SUBJECT: 1125 North Gate Rd., Walnut Creek
APN: 138-180-002, Central San Response
Subdivide lot into 19 single family residential lots

TO: Everett Louie, Project Planner
FROM: Samantha Harris, Transportation Planning Section
DATE: August 28, 2024
SUBJECT: 1125 North Gate Road (CDSD24-09696)

Figure 2: CDSD24-09696 Seismic Hazard & Alquist Priolo Zone Map

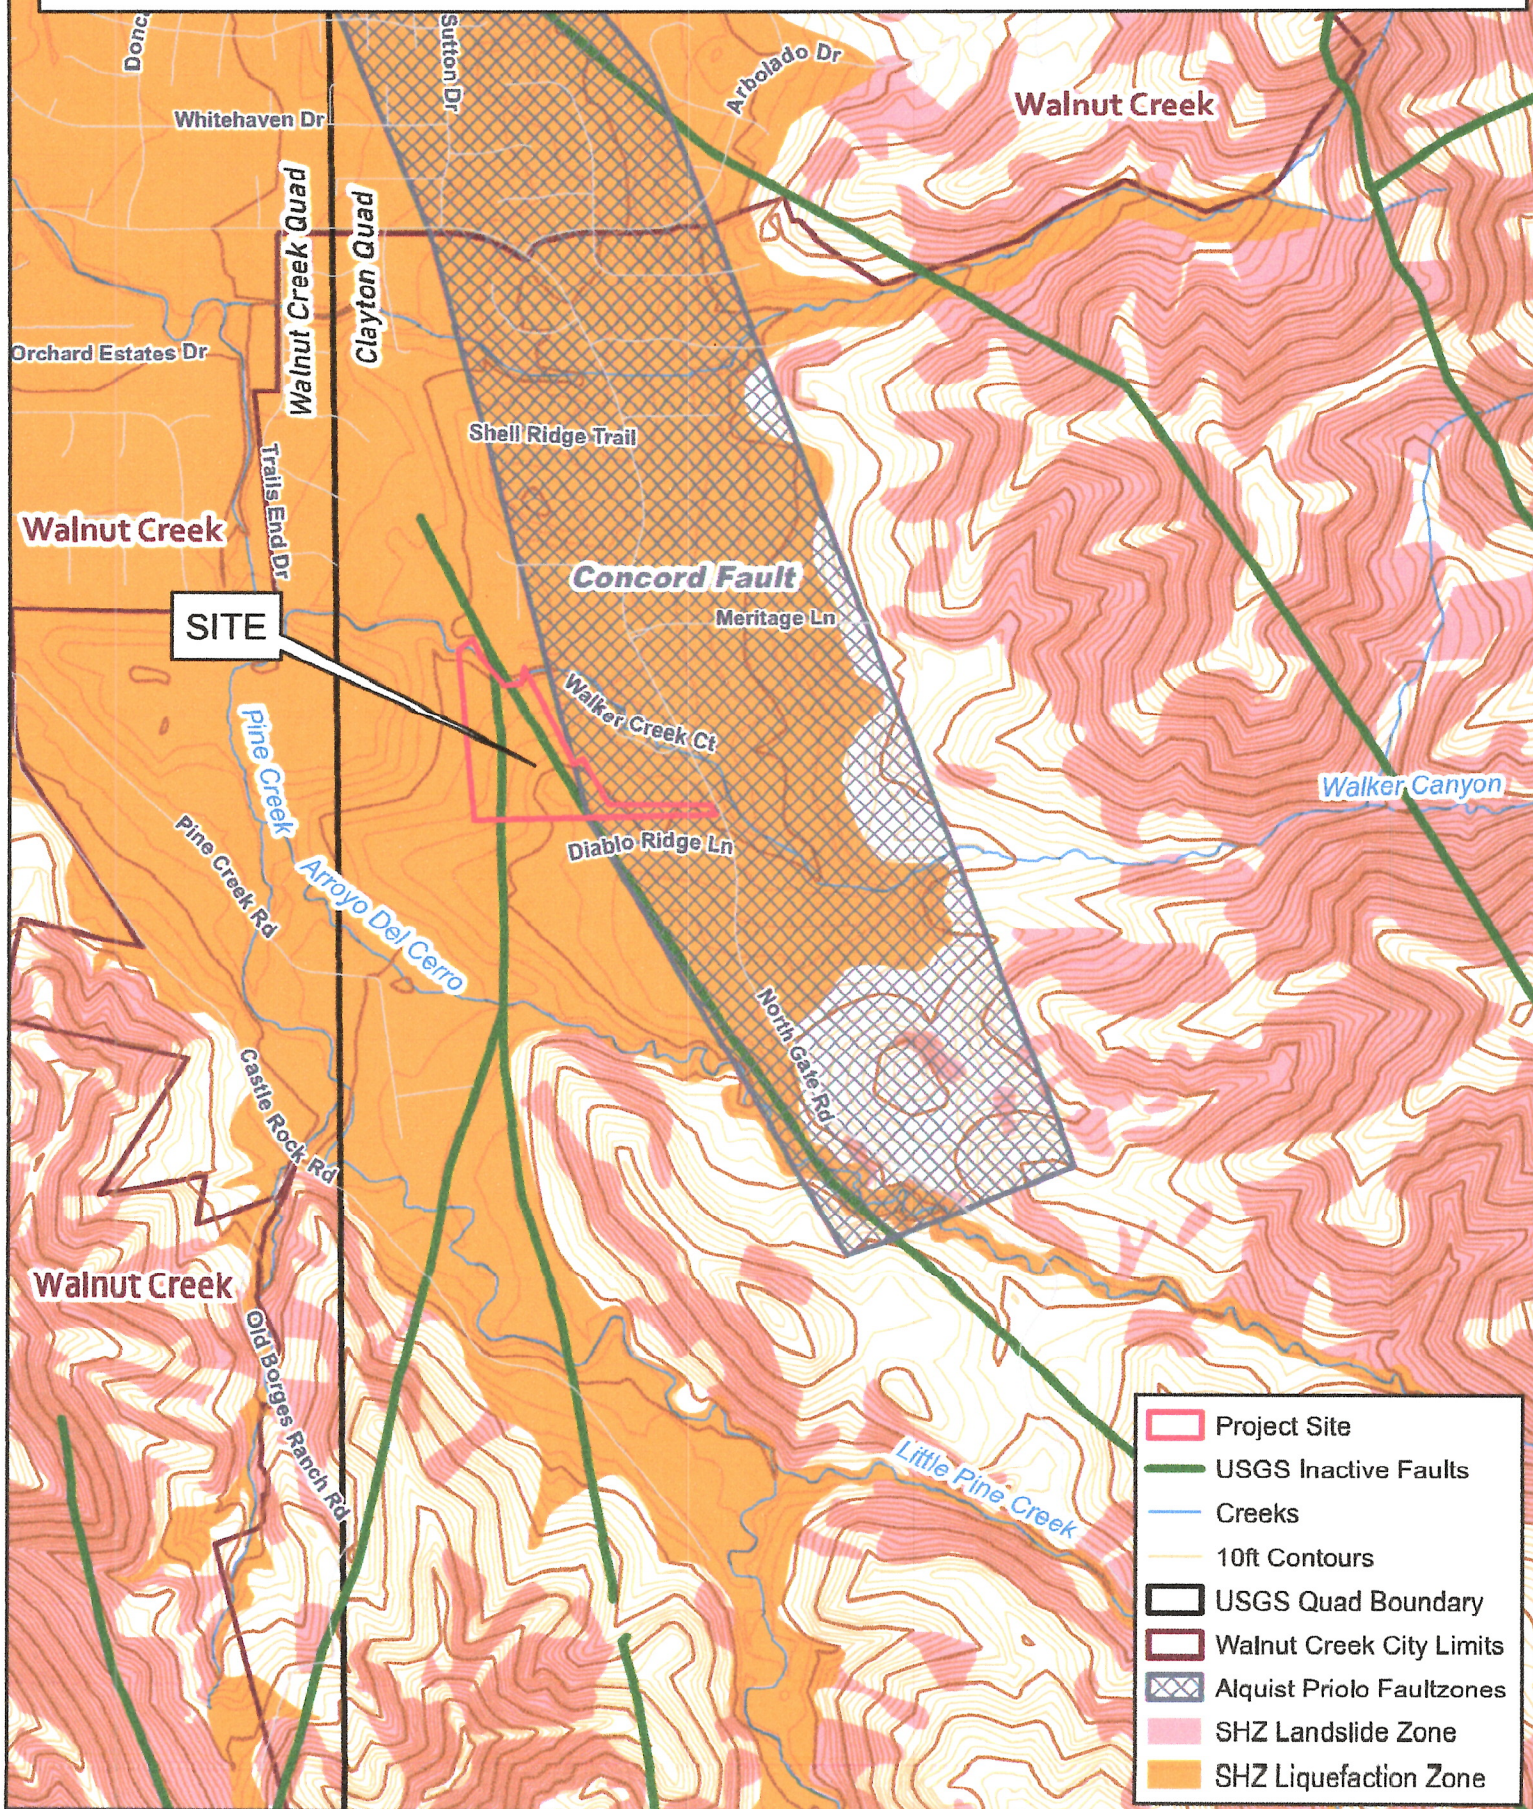
The project requires an updated design level geotechnical report. Furthermore, since the Engeo report was issued in 2015, the CGS has included the CSD24-09696 Project Site (as well as other valley floor areas in the North Gate Road area) in the Seismic Hazard Zone for liquefaction induced ground failure. It is also pertinent to note that the CGS is in the process of updating the Earthquake Fault Zone (EFZ) Map. We do not know when the updated SFZ map will be issued. Potentially the revised EFZ map could result in changes to the width, orientation and boundaries of the Concord fault EFZ map in the North Gate Road area.

As Figure 2 of our peer review letter indicates, a relatively small portion of the project site is located within the EFZ that encompasses recently active and potentially active traces of the Concord fault. Additionally, the entire site is within the SHZ zone that identifies lands that are potentially at risk of liquefaction-related damage. Clearly, the application for approval of a Major Subdivision on the project site is subject to the provisions of both the Alquist-Priolo Earthquake Fault Zoning Act,⁶ and the Seismic Hazard Zone Mapping Act.⁷

Figure 2: CDSD24-09696 Seismic Hazard & Alquist Priolo Zone Map

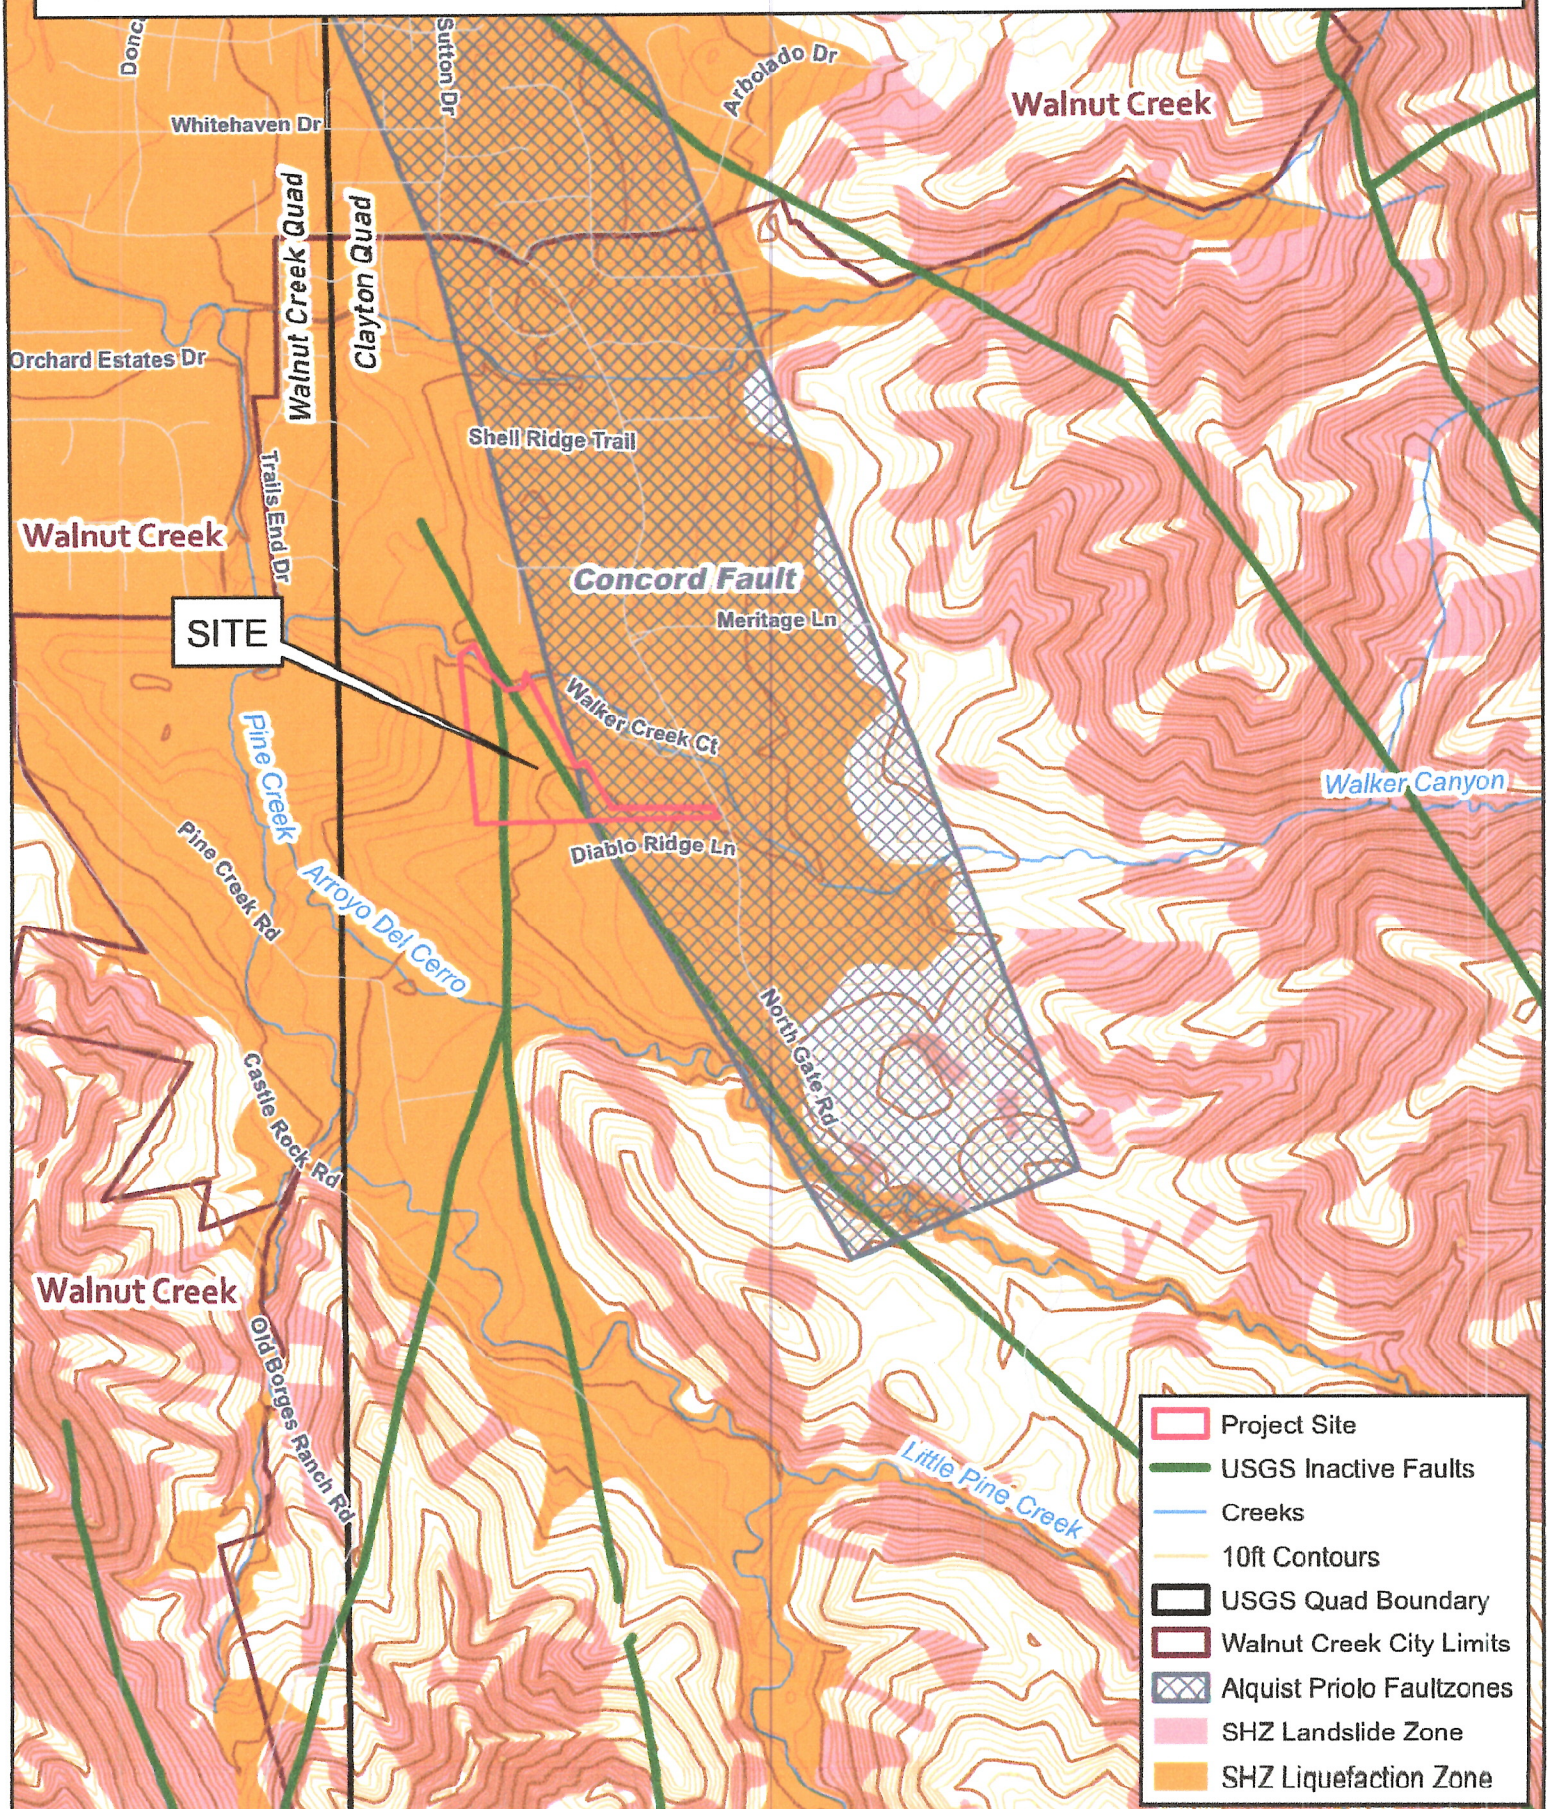
We previously provided background information on the geologic and seismic setting of project site. It will not be repeated here. However, we have included Figure 2 from that peer review. The base map for this exhibit is a topographic map of the project site and vicinity at a scale of 1 in.= 1,000 ft. and with 10 ft. contour interval. The base map also shows (i) the boundary of the Walnut Creek Quadrangle with the Clayton Quadrangle, (ii) corporate limits of the City of Walnut Creek, and (iii) faults mapped by the U.S. Geological Survey (USGS).⁴ These USGS faults are represented by a solid green line and are not classified by activity status. The boundary of the project site is outlined using red lines. Note that two green-line faults are shown crossing the project. One of these faults as a generally north-south trend and the other trends N30°W. These faults converge near the northern boundary of the project site. On this base map, the following hazard areas have been delineated by the California Geological Survey (CGS):
